| ***V-2026-18*** | ***Staff Report – September 17, 2026*** |
| ***Application Type:*** | Area Variance |
| ***Project Address:*** | 316 Delaware Street, Syracuse New York 13204 (Tax Map IDs: 092.-09-25.1) |
| ***Summary of Proposed Action:*** | The applicant proposes a transparency variance in ground floor, land use is " dwelling, multi-unit ". The proposal contains 29 residential units. As the parcel has 1 primary street frontage and two secondary street frontages, the applicant proposes 21.88% ground-floor transparency along the primary street frontage at south side of the building along Delaware Street, 8.5% secondary street frontage at East side of the building along the Kellogg St., 20.7% secondary street frontage at West side of the building along Grace St., requiring an Area Variance relief of transparency. As multi-dwelling residential structures with four or more units are required to provide a minimum of 30% transparency (windows and door openings) on the ground-floor façade facing a public street.<br><br>Dwelling multi-units land use types are permitted by right under the regulations of the R-5 Zone District.<br><br>Site changes include construction of 15 Parking spaces

- Exterior Elevations (Sheet A2.1), prepared by Holmes-Kinh Kallquist & Associates, Architects, LLP; dated: 10/23/2023; scaled as noted.

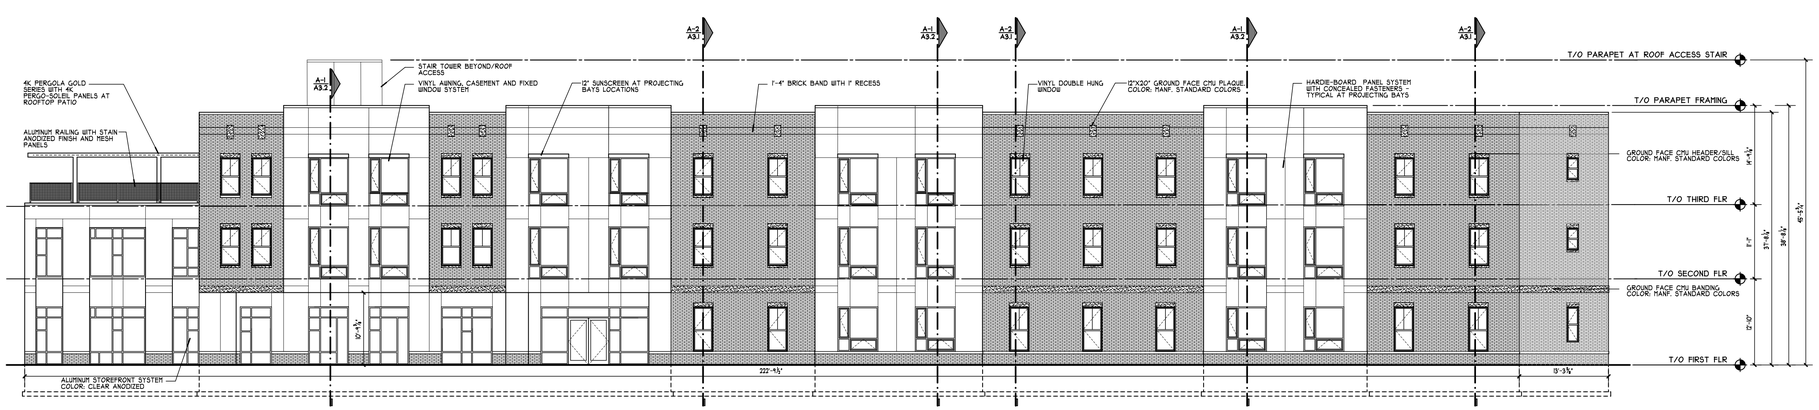
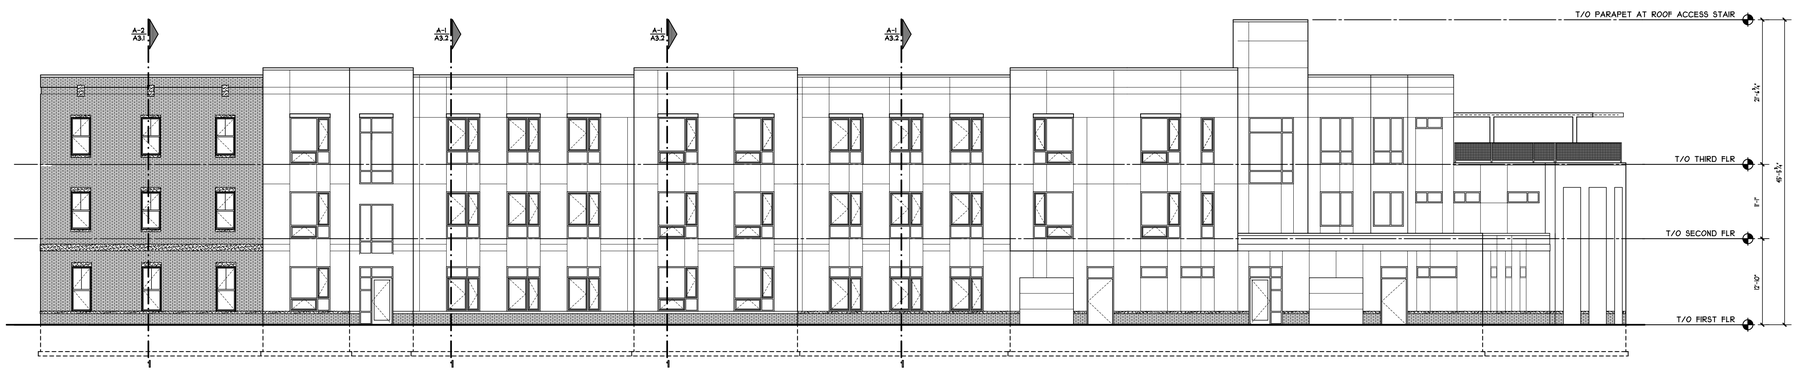
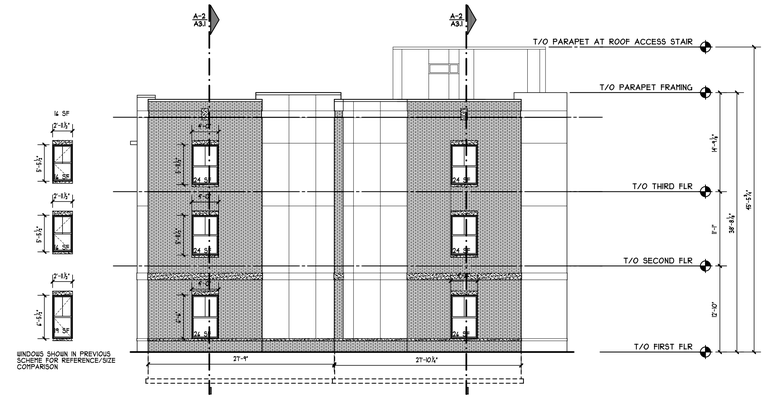
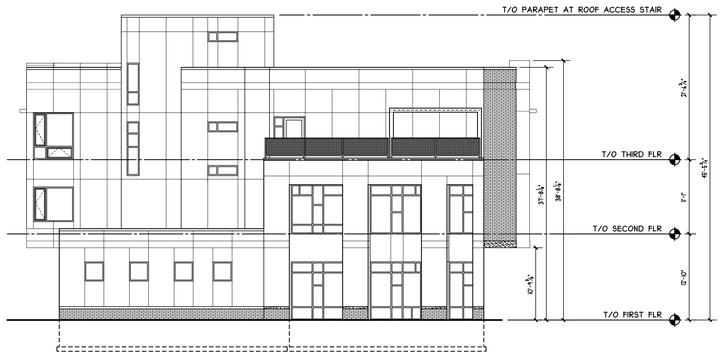
| **Prohibited in Zoning Code** | **Proposed by Applicant** |
|---|---|
| minimum of 30% transparency required (windows and door openings) on the ground-floor façade facing a public street. | Applicant provided 21.88 % transparency for the ground floor at South side of building along Delaware Street (Primary frontage)., 20.7% at West side along Grace St (secondary frontage). And 8.5% at East side along Kellogg St (secondary frontage)., |

The proposed reduction in first-floor transparency from 30% to 21.88% at south side, 20.7 at West Side and 8.5 at East side will not produce an undesirable change in the character of the neighborhood or create a detriment to nearby properties. The proposed multi-dwelling residential building aligns with the scale, density, and physical context of the surrounding R-5 zone district.

A feasible alternative to achieve the required 30% at first-floor transparency does not exist. The applicant design placed bedroom windows, Delaware Street, and Kellogg Street , while the remaining portions of the units contain bathrooms, and storage areas that cannot accommodate additional fenestration. Increasing window area would require a full redesign of the unit layouts and would disrupt the established architectural rhythm of the façade, which is based on brick tower elements and proportional window placement. Therefore, strict compliance with 30% transparency requirement is not feasible without compromising the functional layout and architectural integrity of the building. As per SZO Article 7.3, A.(1) C. a lesser amount may be allowed if limited by state and/or local energy codes.

The requested variance is substantial. The proposed 21.88% at Delaware St. (this is a primary street frontage and all the units are placed along this frontage), 20.7% at Grace St.(this side is secondary street frontage and community room, maintenance storage and mechanical room is located) and 8.5% at Kollege St. (this is also secondary street frontage that two units are located at this side which they already have transparency from primary side also). Overall average in three side of ground floor transparency is 17% represents a significant deviation from the required 30% standard, maintaining visual interest and architectural modulation along the street front.

| | **Adverse Effect (Criteria Met):**<br><br>The requested area variance (21.88, 20.7, & 8.5 % provided out of 30% transparency) will not have an adverse physical or environmental effect on the neighborhood. The site incorporates 15 off-street parking spaces, adequate landscaping, and proper site screening to mitigate any physical impacts.<br><br>**Self-Created Difficulty (Criteria Not Met):**<br>While the difficulty is technically self-created due to the specific architectural design choices. |

| ***Staff Recommendation:*** | **Staff recommend approving this project as proposal meets three criteria.** |
| ***Recommend conditions if approved:*** | 1. The applicant shall comply with the general conditions for approval on the Variance application. (See the attached sheet General Conditions for Variance Approval)<br>2. The proposed Area variance only grants the "Ground floor transparency 8.12% conflict along Delaware Street at South side of the building along Delaware St.", 9.3% conflict along Grace Street at West side of the building and 21.5% conflict along Kellogg Street at East side of the building. In the 316 Delaware St. The applicant shall submit an additional Variance application if they intend to expand the proposed use. |
